UNITED STATES PATENT AND TRADEMARK OFFICE

APPLICATION NO.	FILING DATE	FIRST NAMED INVENTOR	ATTORNEY DOCKET NO.	CONFIRMATION NO.
09/911,949	07/24/2001	Thomas Louis Russo		5696

**Advisory Action**

Application Control Number: 09/911,949  
Applicant: Russo, Thomas Louis  
Art Unit: 1772  
Examiner: Patricia L. Nordmeyer

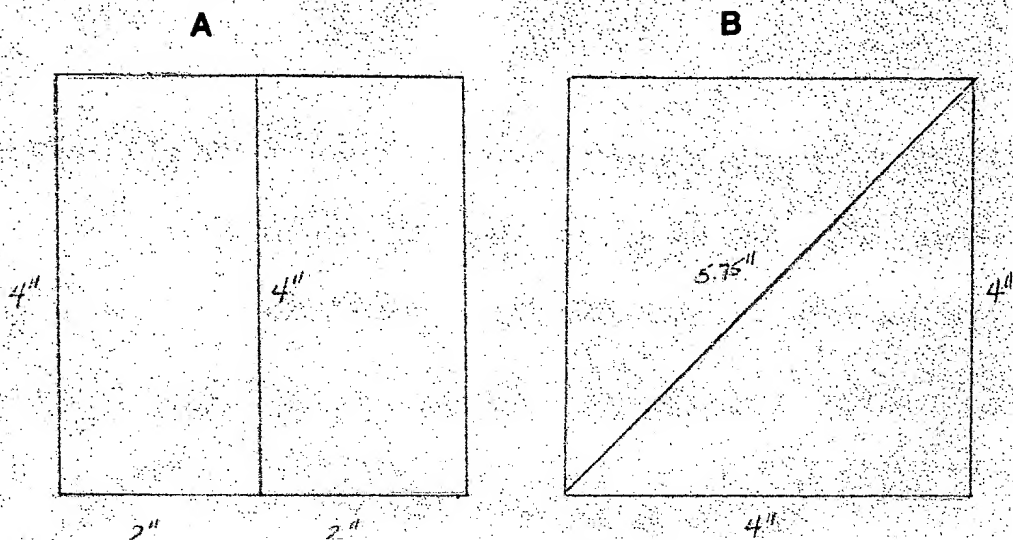
Jaszai discloses the claimed wrapping system above including the chambers maximizing available pad surface (Figure 20, #14); however, Jaszai fails to disclose the chambers being substantially conical in shape.

I reviewed your suggested section (Column 7 lines 33-35, FIG 20,#14)" into two wall chambers 14 is arranged in a continuous zigzag. Each wall chamber 14 elongated in zigzag is subdivided into generally U-shaped compartments by intermediary taps 9." a did note that Mr. Jaszai did describe a specific shape of each compartment as U shaped and that the subdivision was created by a zigzag design format. That allow me to understand that our compartments were cone or triangle shape and that we had a specific triangle or cone pattern to develop our subdivision of our pads. And that a cone shape would not work with Mr. Jaszai's format because our cone or triangle designs have a base end on one pad perimeter and the top end of the cone or triangle at the opposite perimeter . Cone shape chambers allow our pad to present a higher profile, because pad height is determine by the smallest chamber dimension.

The sketch above will hopefully help illustrate the statement that a chamber height is determined by its smallest dimension. A and B represent a four inch square, consider then inflatable pads. When we divide pad A in half using a rectangle chamber like Mr. Jaszai's wrapping pad the smallest dimension is 2 inches, but when you use a cone shape or triangle shape similar to pad B like our pad the smallest dimension is 4 inches. The cone shape does make a significant difference in obtaining a higher pad profile providing a void fill pad with greater impact protection and requiring less void fill pads to pack like shipping boxes using lower profile pads.

Ms. Nordmeyer, will that example be sufficient to allow me to use shape as an important part of my invention?

A fourth type of the basic inflatable is shown in FIG. 4 which comprises a single sheet of thermoplastic material 20 to which is attached individual sheets of thermoplastic materials forming individual inflatable units 22 each having its own inflating valve 23 thereon.

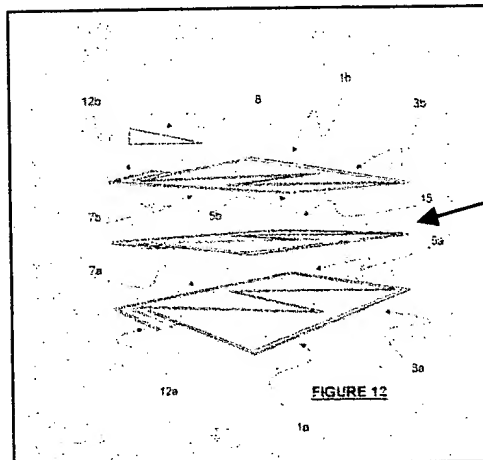
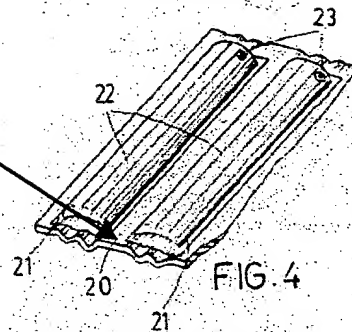
Office summary statement “ The inflatable article contains an intake tap for each of the separated inflatable areas ( Columns 4, line 56 and figure 4,#23) This is a significant difference to my invention in that there are no individual intake taps that each zone controls a complete side of a pad and the air moves freely through all connected cone shaped air chambers in a zone. That my invention is designed to be filled with air when constructed and can be reused in the same state, and only if you want to deflate our pad to store reuse is simply blowing through a portal tube that fills all zones and all chambers in one action and by simply folding the portal tube and tucking it under a small retaining film, air remains in the pad providing impact protection with multiple zones each with connected chambers that redistribute impact compressed air.

Office summary statement “Each area is inflated or deflated independently through intake and exhaust taps located in the perimeter of the article ( Figure 4,#23). Here again I thought you were pointing out the deference between my invention with no need for intake taps, my invention was designed to be made from the film layer, there are no additional valves or taps one run through a film press with my design will create a complete operating high volume void fill unit. This would keep the cost down add allow it to be an alternative to void fill that can not be reused.

Magrid's central film 20 mentioned is a single film that separate chambers 22 are attached to, each with a separate valve 23.

Each chamber would need to be inflated and deflated independent of all others, defeating the purpose of air being able to move to another chamber in a zone when impact occurs. Chambers under impact pressure may simply bust causing the package to move possibly impacting other chambers destroying the integrity of the packing system

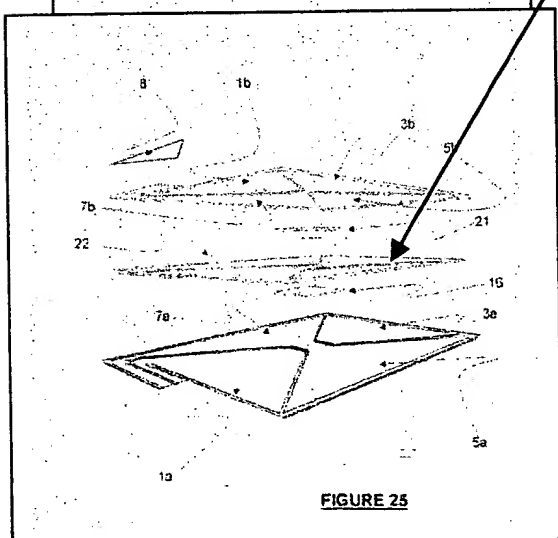
Office statement "Magrid discloses the claimed invention except for a second layer on the opposite of the first layer which formed separate areas on the pad surface. It would have been obvious to one having ordinary skill in the art at the time the invention was made to place individual sheets of plastic on the opposite side of the central layer which are sealed to the central layer to form inflatable areas having their own valve control on the surface of the article, since it has been held that mere duplication of the essential working parts of an article involves only routine skill in the art." Magrid's invention more closely resembles Jaszai or Soroka if designed as a impact resistant wrapping packing system. Just adding a second layer of film on the opposite of the first layer, would not provide a high profile void fill pad with four separate zones each containing connected coned shaped air chambers designed specifically to be high impact protection for void fill applications. Adding that second film with multiple valved chambers would make this a very costly void program and would more closely relate to Jaszai meant to wrap an article.

My central film is actually a complete third film layer the same size as both outer layer films positioned in between the two outer film layers, creating four separate zones, two zones above the central layer and two zones below the central layer. Creating an even more impact resistant pad because now an impact on a zone is cushioned by the separate zone below, spreading the force of the impact over several other zones. It is still designed to be filled when constructed and can be reused in that state. Or can be deflated by cutting open the portal tube and reused at a later time by simply blowing on the portal tube that fills all zones and all chambers in one action.
